# ALERTE À LA SÉCURITÉ

## Alerte à la sécurité concernant les chaudières NTI

**IMPORTANT SAFETY NOTICE – IMMEDIATE STEPS REQUIRED**  
**FTG SERIES BOILERS**

February 13th, 2026  
**FTG Safety Advisory – Mandatory Upgrade**

### **STEP 2 — Replace ignition electrode**

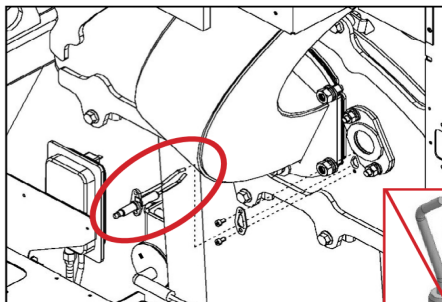
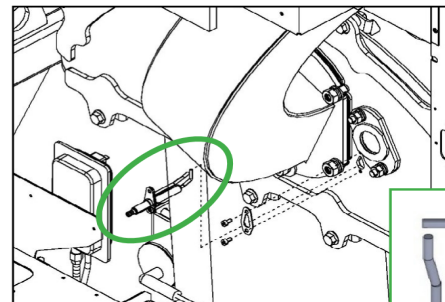
- 1** Remove existing electrode (2 T20 screws) and discard gasket

- 2** Install new electrode with new gasket (2 T20 screws)

Longer ceramic insulation for better spark characteristics

Failure to replace the ignition electrode with the new electrode illustrated above may increase the risk of delayed ignition.

System Identification & Access

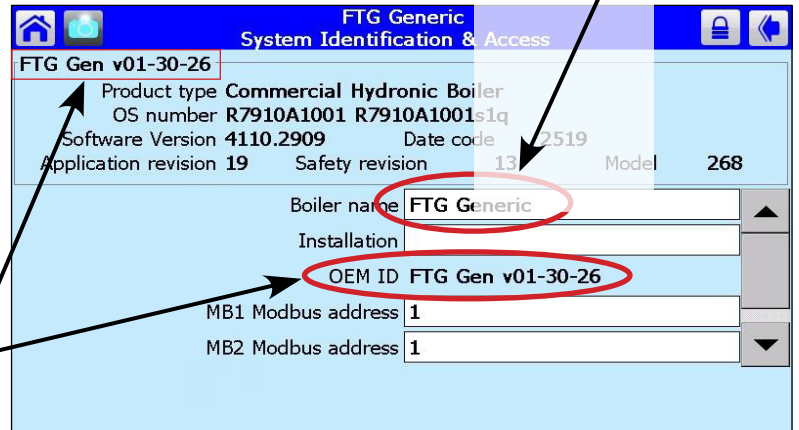
Replacement controls intended for use on FTG series boilers will have a 'version ID' (OEM ID) beginning with "FTG Gen v". If the date code isn't 01-30-26 or newer, DO NOT use the control – contact NTI for a replacement.

Modulation Configuration

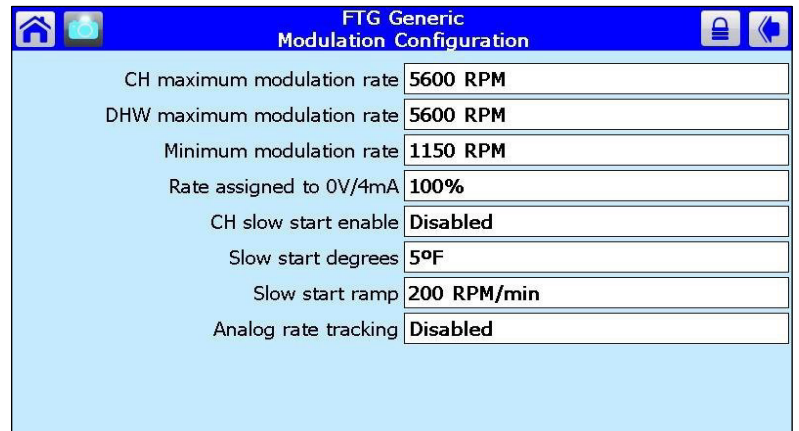
Since the replacement control is generic to all FTG series boiler models, the minimum and maximum modulation rates must be set to the applicable values in the table below.

## 3 Pulses per Revolution Adjustment

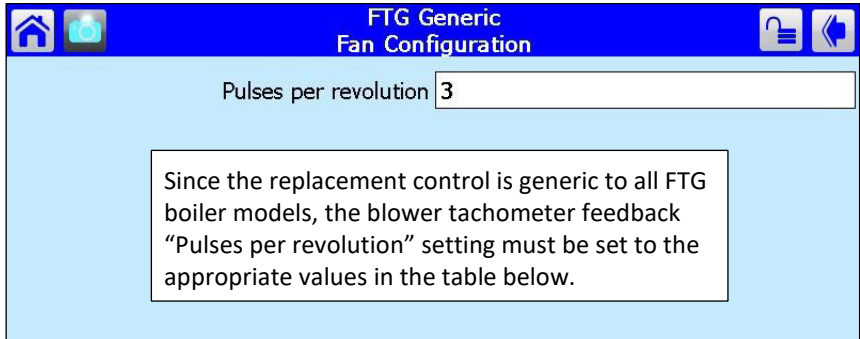
The parameters described in the following paragraphs **MUST** be properly adjusted. Failure to correctly adjust the control parameters as required for the respective boiler model, specifically the **Modulation Rate** and fan **Pulses per Revolution**, will cause the boiler to operate at the incorrect firing rate thereby creating a risk of fire or explosion that could result in property damage, physical injury or loss of life
